**YARRA CITY COUNCIL**  
**Internal Development Approvals Committee**  
**Agenda**

**1.1 PLN16/0913 - 47 Coppin Street, Richmond - Use of the land for a Restricted Recreation Facility (gymnasium) and associated buildings and works.**

1. This report provides Council with an assessment of planning application PLN16/0913 at 47 Coppin Street, Richmond for use of the land for a Restricted Recreation Facility (gymnasium) and associated buildings and works; and recommends approval subject to conditions.

Figure 1 – Distances from the nearest habitable room windows to the skylight at the subject site.

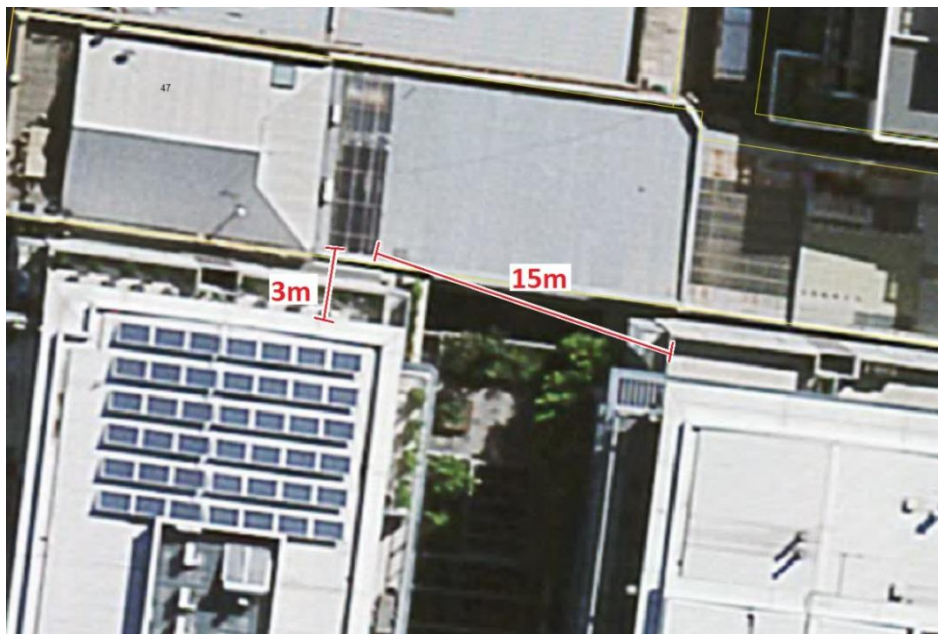
70. An objection was received relating to light-spill from the existing skylight within the roof onto nearby habitable room windows. Whilst upgrades to this section of the roof are included in the recommendations made within the acoustic report, it is noted the roof will continue to be fitted with clear glazing.
71. The nearest windows to the skylight are located at top floor of the Cubo development, abutting the subject site to the south. These windows do not have direct line of sight to due to a balcony and balustrade between the windows in question and subject site (Figure 1 and 2).

The nearest windows with direct line of sight to the skylight are located approximately 15m south-east of the subject site (Figure 1). Given lights within the first-floor room will be downward facing, only indirect light will exit the skylight. For these reasons, it is unlikely any unreasonable light-spill from the skylight would affect any existing habitable room windows. Additionally, in the event of a permit being issued, standard amenity conditions will apply, which includes that the amenity of the area must not be detrimentally affected by artificial light.

Figure 1 – Upper form recess in relation to direct views from the south side of Johnston Street

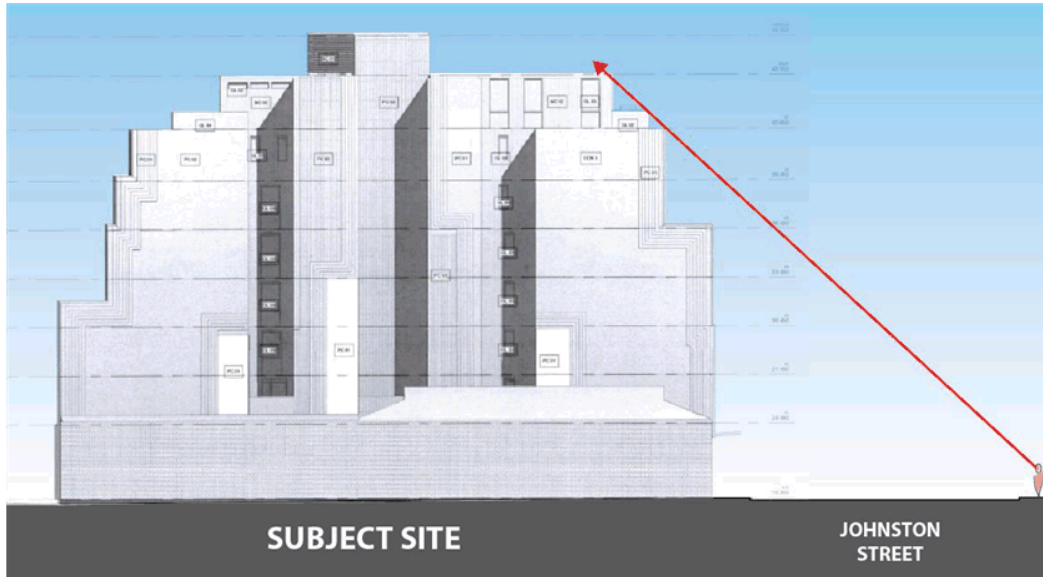
Above this, the proposal consists of an 'upper form' comprised of another two storeys with an additional recessive level further above (with additional recessive services 'cap'). Although the overall height of the proposal slightly exceeds that which is envisioned by the JSLAP, the uppermost storey has been designed so that it will read as a diminutive and recessive architectural feature as viewed from the Johnston Street public realm in direct views. Refer to Figure 1 below. Further, urban environments generally benefit from variation in building heights and skyline profiles and the additional storey above and beyond that envisioned by the JSLAP will contribute

to the achievement of this in longer views, in a manner that is respectful to the identified preferred future character for Johnston Street. The overall height is therefore appropriate.

Figure 2 – Recommended northern interface amendments

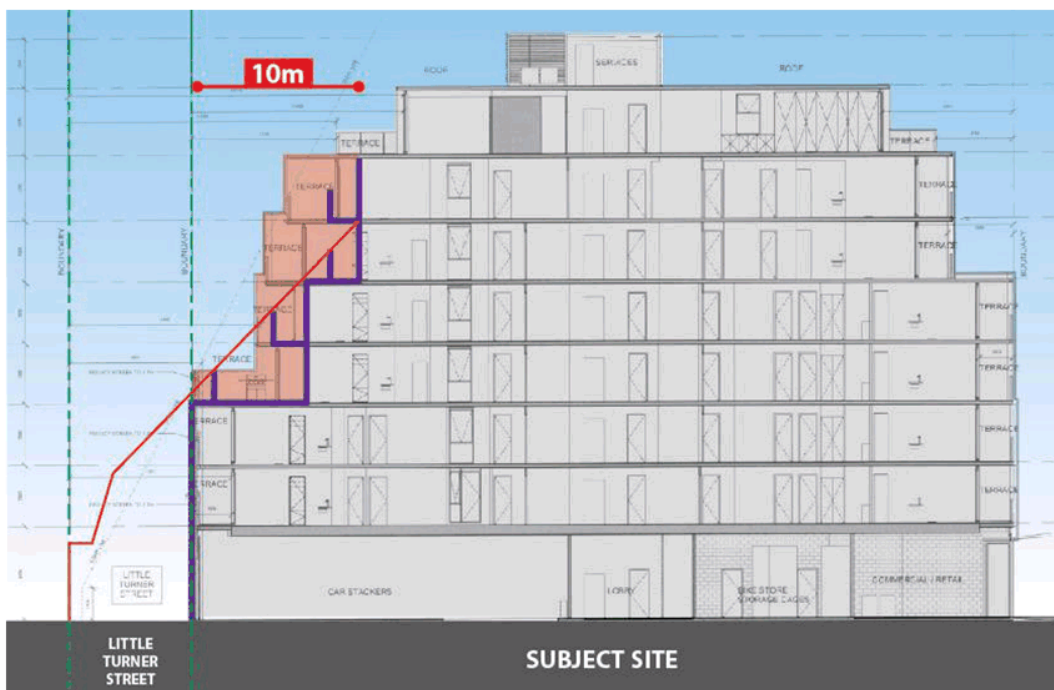
We therefore consider a more appropriate urban design response to be achieving general compliance with Standard B17 of Clause 55.04 (as measured from the northern boundary of Little Turner Street) for all built form within 10m of the site's northern boundary. Refer below. This can primarily be achieved through minor setbacks to the balustrading of north facing terraces and balconies, particularly at Level 3 where the proposed balustrading contributes unnecessarily to the visual bulk of the proposal as viewed from the north. Additional design mechanisms discussed in 'Design Detail' would further reduce the bulk of the proposal as viewed from this aspect.
